C-900 - ADDENDUM

Addendum No. 4

Date:	<u>April 1, 2019</u>
Issued To:	<u>Plan Holders</u>
From:	<u>Alan Plummer Associates</u>
Project:	<u>Wastewater Treatment Plant Expansion</u>

TANK 4 ASSEMBLY

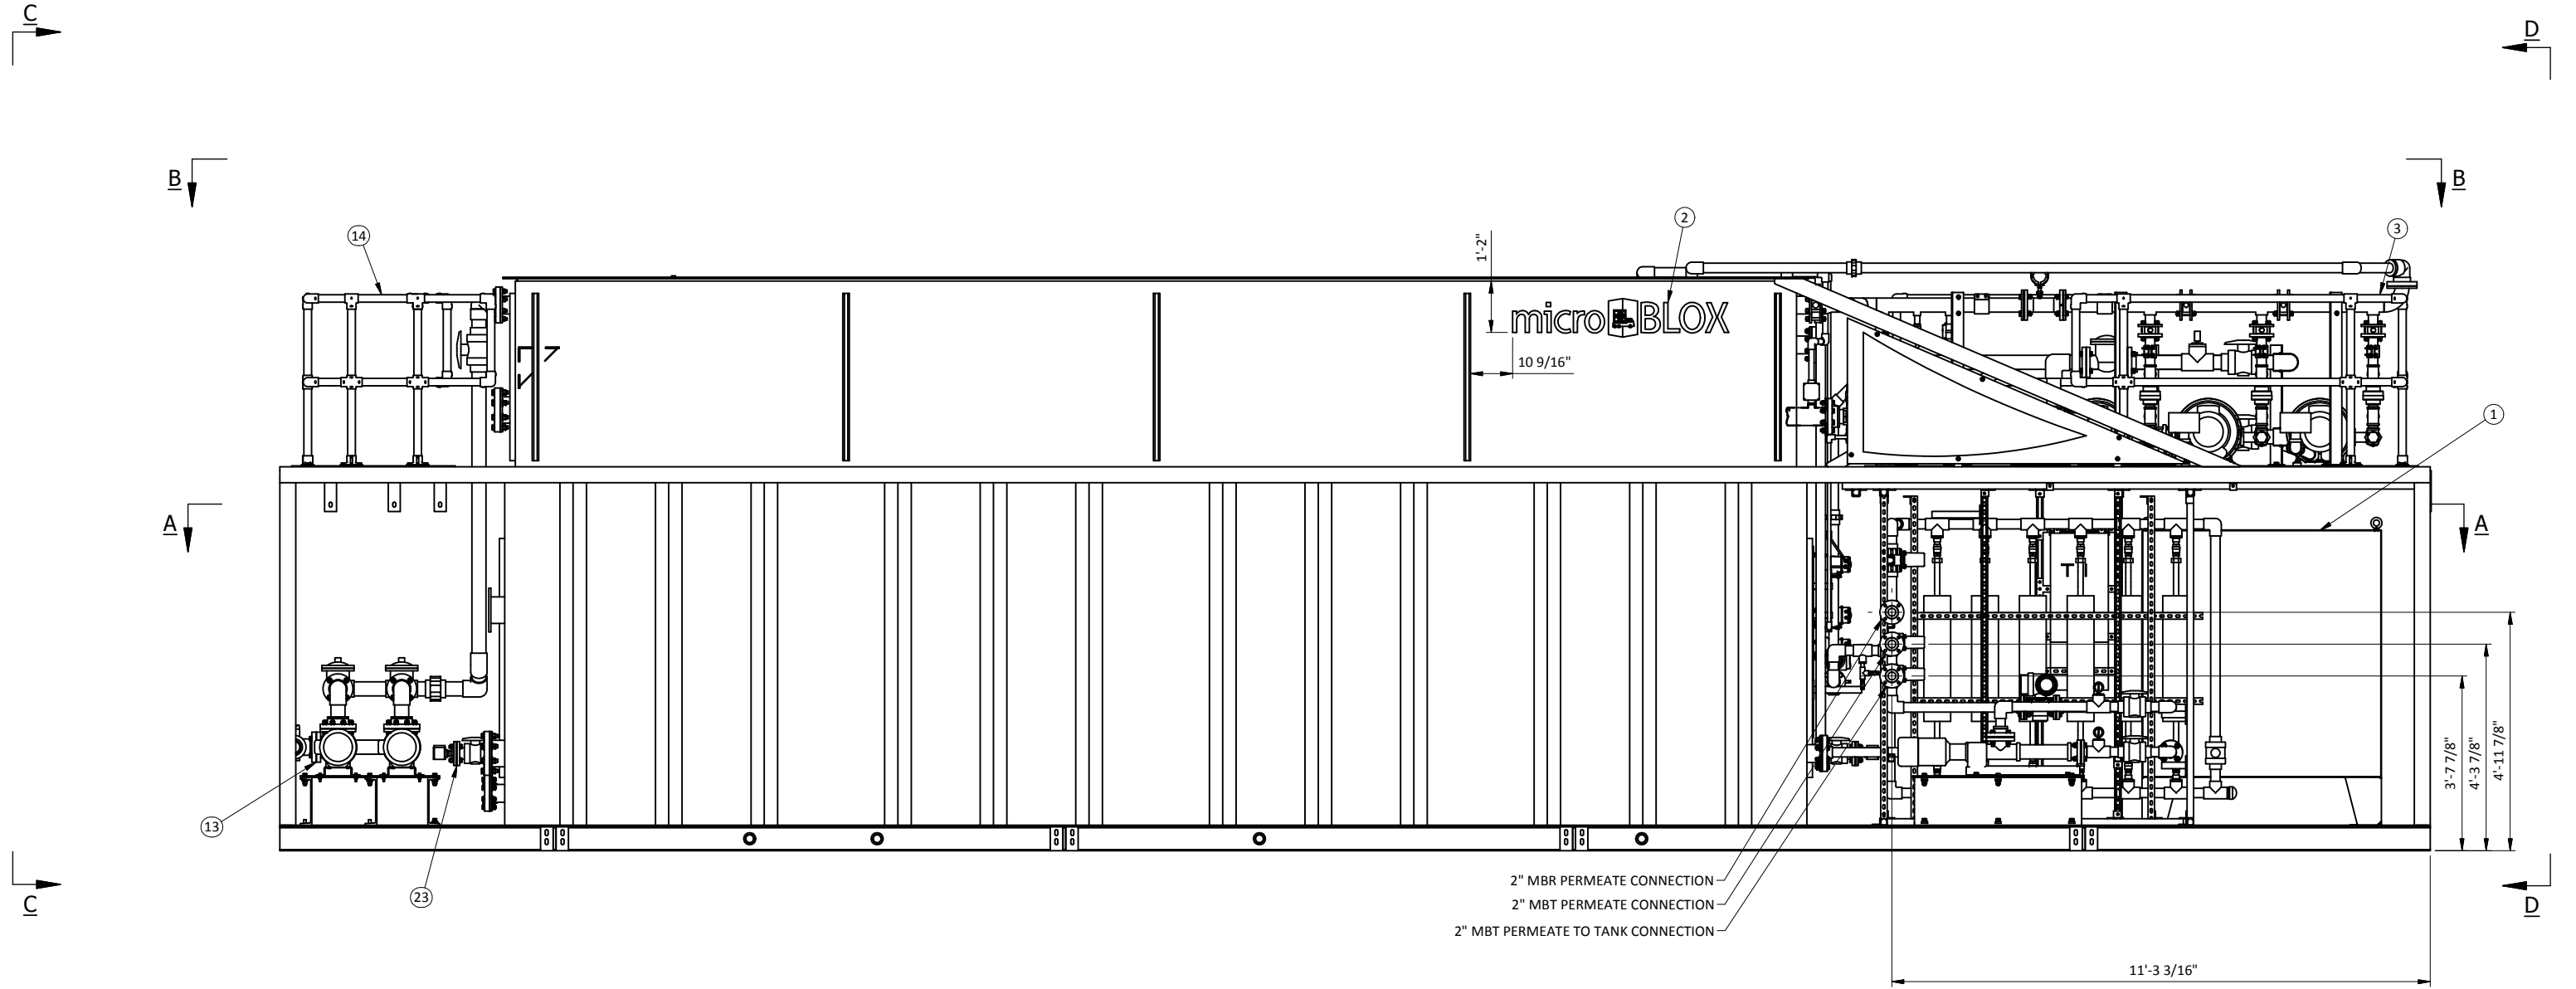
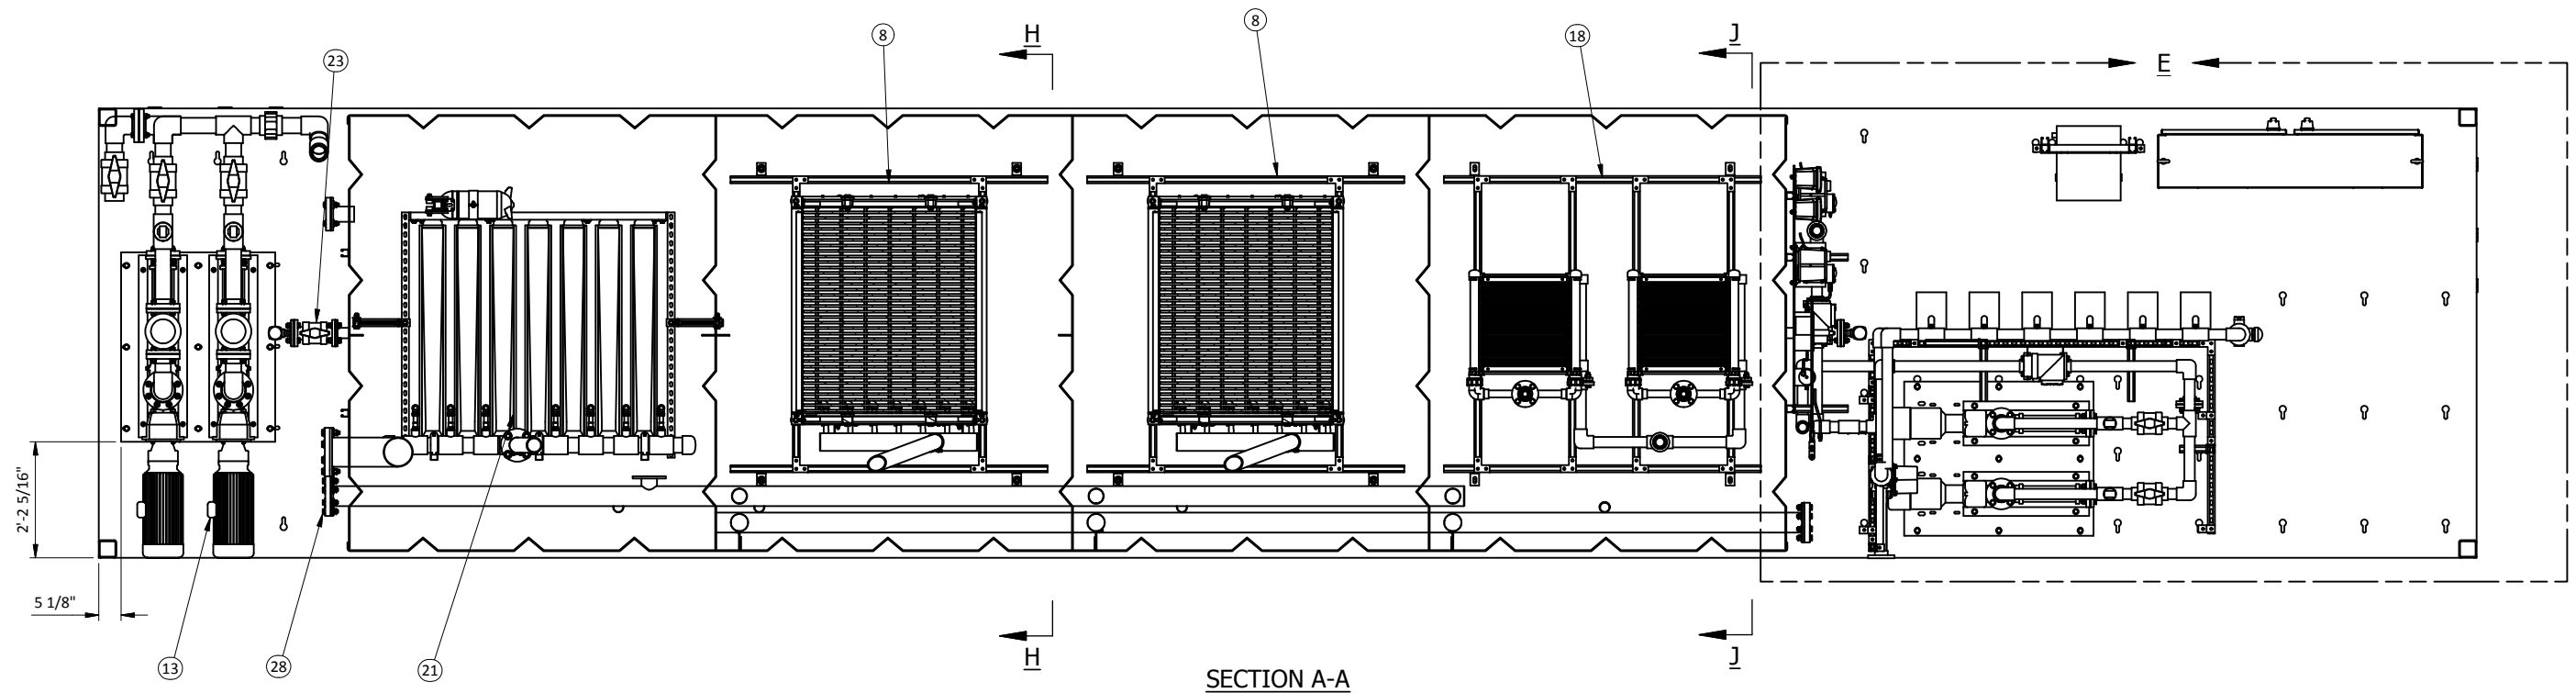
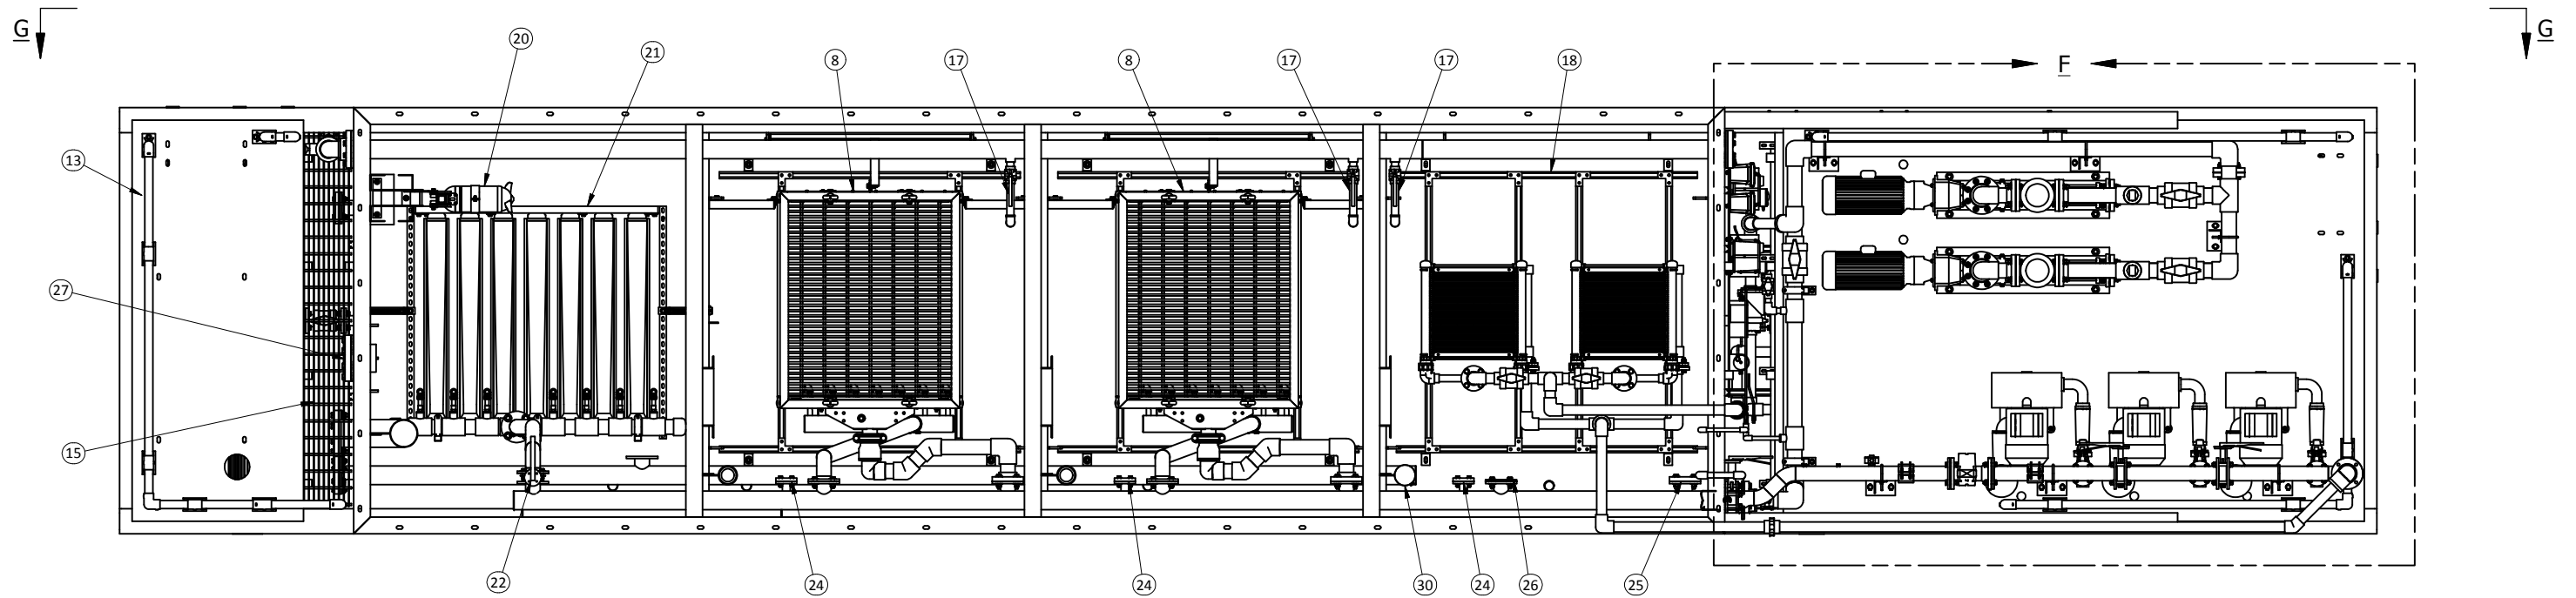
- A. Will Ovivo supply the Influent pumps (pumping from the existing concrete Anoxic/EQ Tank to the Temporary Treatment System) and the WAS pumps (pumping from the Temporary Treatment System to the sludge holding tanks)?

- 1. Response: Yes; Ovivo will supply the influent submersible pumps and a WAS pump with the temporary treatment system (see attached). The contractors will need to provide the interconnecting temporary piping and electrical for these pumps.

FLOOR PENETRATION CURB DETAIL

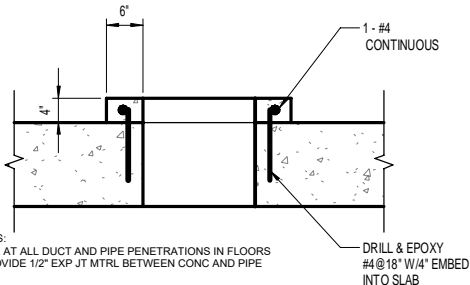
- A. This addendum forms a part of the Bidding and Contract Documents and clarifies, corrects or modifies the Project Manual and Drawings as described below.
- B. This addendum consists of 4 page(s) and the following attachments:
 - 1. Temporary Treatment System - MicroBLOX Unit 4-4-300
 - 2. Structural Detail for inclusion on Sheet No. S4-04 – Floor Penetration Curb Detail.
